DESCRIPTIVE REPORT

Registry No. H-11358

General Locality Port Frederick

Sublocality Hoonah Point and Pinta Rock

Figure 2. Inaccurate Sound Velocity Resulting in "Smiles"

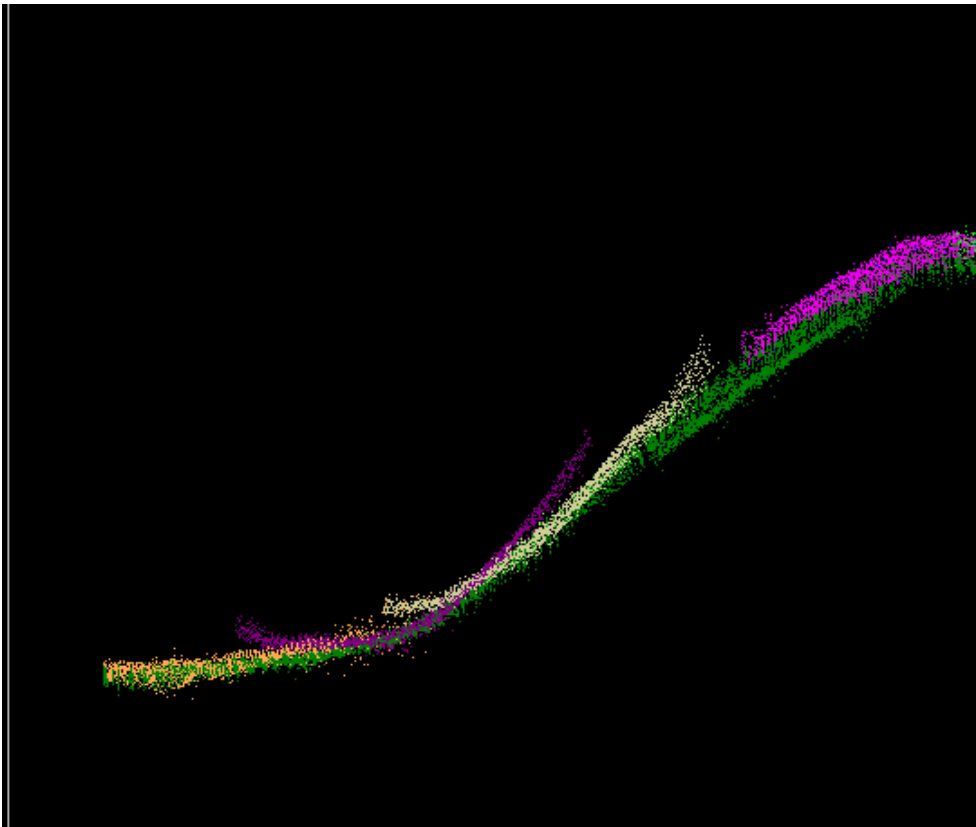
After correction for sound velocity in CARIS HIPS & SIPS, a small amount of lines west of Halibut Rock still exhibited the characteristic "smiles" indicative of inaccurate sound velocity corrections (*see Figure 2*). All areas of problematic data were surveyed using the Reson 8101 on RA5 (1006). Despite the best efforts of the Hydrographer to conduct sufficient sound velocity casts distributed both spatially and temporally, and to correct for sound velocity errors in post processing, sound velocity errors were still noticeable. To compensate, the Hydrographer, where possible, increased filtering and rejected soundings obviously in error on the outer beams.⁸

⁸ A comparison of soundings in these areas reveals no significant discrepancies.
